Docket Item #8
SUBDIVISION #2005-0008

Planning Commission Meeting
December 6, 2005

ISSUE: Consideration of a request to subdivide the subject property into two lots.

LOCATION: 30 Sunset Drive

Plan A

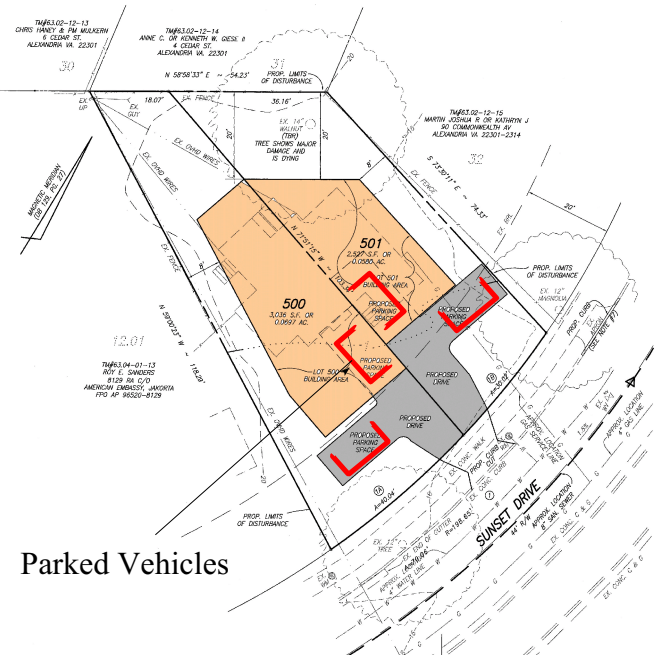
At staff's request, the applicant provided a conceptual parking and curb cut scheme as part of the subdivision application (shown here as Plan A). After reviewing the plan, staff found that it was not acceptable, both from a safety and design perspective. The location and configuration of the two driveways on the inside portion of a curve located in close proximity to the intersection of Commonwealth Avenue has poor sight distance which results in a hazardous condition for vehicles backing out onto the street. Staff found that the location and nature of the proposed curb cut and associated parking did not conform with the character and architectural style of the developed block face. Staff met with the applicant to discuss its concerns.

- F-1 T&ES does not support separate driveways for each of the properties as illustrated on the plan [*Plan A*] because the location and configuration of two driveways on the inside portion of a curve located in close proximity to the intersection of Commonwealth Avenue has poor sight distance which results in a hazardous condition for vehicles backing out onto the street.

Plan B

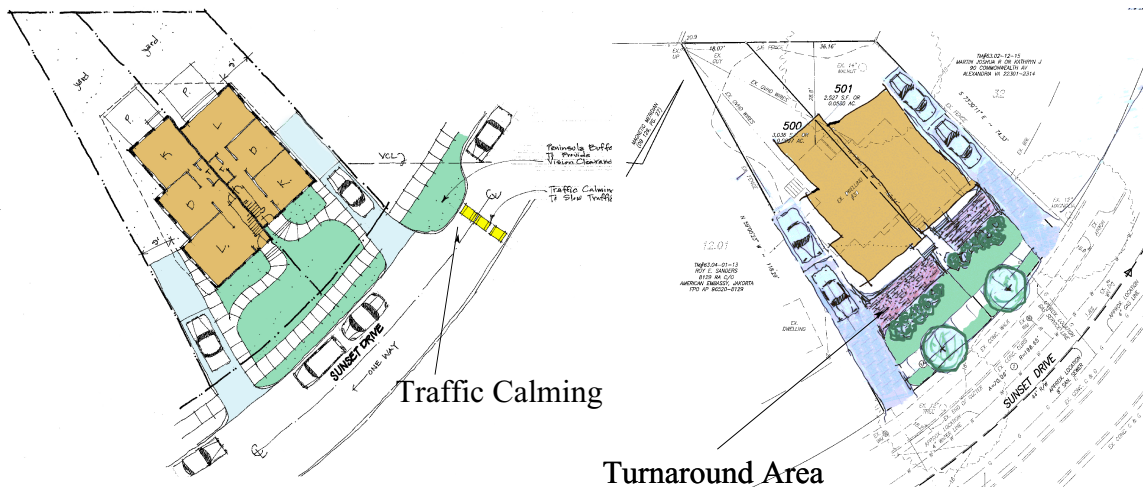
The applicant provided a subsequent scheme (pictured here as Plan B). The proposal included a single 16-foot wide curb cut for both properties, and front loaded garages and surface parking in the front yard, resulting in a great deal of paving in the front yards of the proposed semi-detached dwellings. The plan depicted the T&ES recommendation that, "The proposed subdivided properties shall be served by joint access with a single driveway entrance not to exceed 16 feet in width. Provision for an on-site turnaround shall be provided to the satisfaction of the Director of T&ES." Although the plan creates a safe condition for this difficult road segment, it is one that is drastically out of character with the street and neighborhood.

Plan D

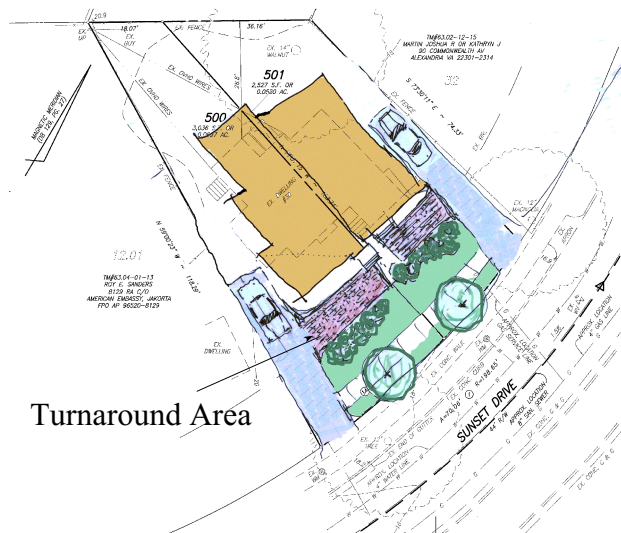
Staff proposed another plan, labeled here as Plan D, which proposed two curb cuts and tandem parking, which would require a special use permit (for tandem parking), but with an on-site turnaround to prevent backing out on to the street. The turnaround area would be in the form of a pad at the front of each dwelling covered in pavers and screened with landscaping to look like a front patio when not being used as a turnaround. A modification would have to be included in the special use permit to allow for more than 50% of the side yard to be used for parking. This design is closer to addressing design concerns, but from a safety perspective, T&ES found that the turnaround area would likely not be utilized for its intended purpose with two vehicles on the property, making safety still an issue.

While there does not appear to be a solution that satisfies both the safety and compatibility criteria for a curb cut that complies with the zoning requirements for parking, both P&Z and T&ES agree that a full parking reduction at this location would be an acceptable solution. P&Z and T&ES also agree that a modified version of Plan D, depicted here as Plan E, with a parking reduction of a single space for each lot, would be acceptable. Staff expects that a parking reduction Special Use Permit application will be filed in order to proceed with development.
